JRPP No:	2011SYE064
DA No:	DA11/0478
Local Government Area	Sutherland Shire
Proposed Development:	Subdivision Development - Subdivision of One (1) Lot Into 71 Lots
Street Address	446 Captain Cook Drive, Greenhills Beach Lot 1054 (Future Lot 2) DP 1140838
Applicant/Owner:	S Blount (Australand Pty Ltd)
Number of Submissions:	Nil
Recommendation:	Approval
Report By:	Brad Harris – Environmental Assessment Officer (Planner) Sutherland Shire Council

Assessment Report and Recommendation

Figure 1: Proposed Subdivision Layout

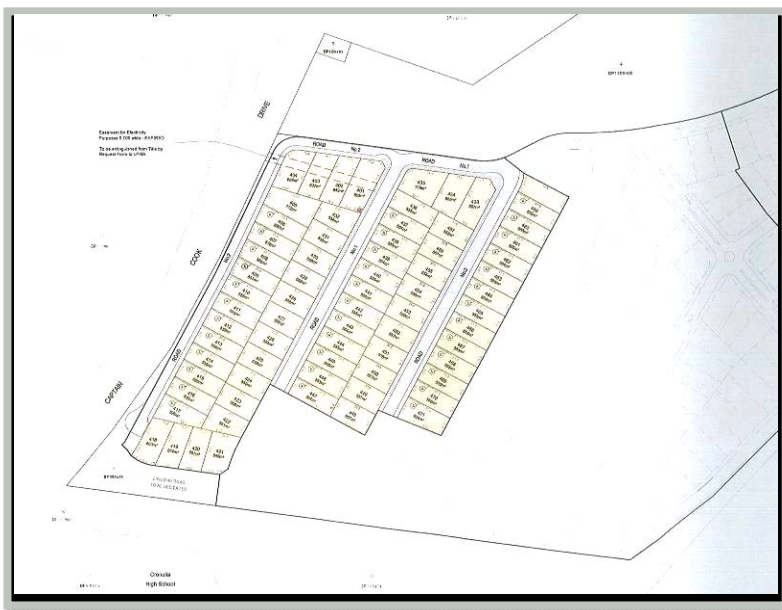
The latest set of submitted drawings present a number of unresolved issues with the road network layout:

- The road network has no obvious hierarchy. It is considered that Road No. 1 should be a collector road, Road No. 3 a local road and Road No. 2 a minor local road. All road reserves and associated carriageway and footpath areas should be widened to comply with clause 2.b.14 of Chapter 7 of SSDCP 2006.

- As with development consent No. 10/1253, to control parking and ensure passing bays are kept clear, street signage will be required.
- The cul-de-sac bowl must have a minimum kerb return radius of 8m (Chapter 7 Clause 2.b.14 SSDCP 2006). It is noted that the cul-de-sac detailed in the submitted drawings can accommodate the minimum dimensions of Council's "T-Head" standard drawing.

- The bus route should have a 9m wide carriageway. Although not subject to approval through this Consent, the bus route recommended by Colston Budd Hunt & Kafes Pty Ltd (Report of November 2010) should be revisited, for example; any bus stops along the western side of Road No. 1, will have to negotiate parked cars and street trees located in the carriageway.

These matters are addressed by recommended consent conditions.
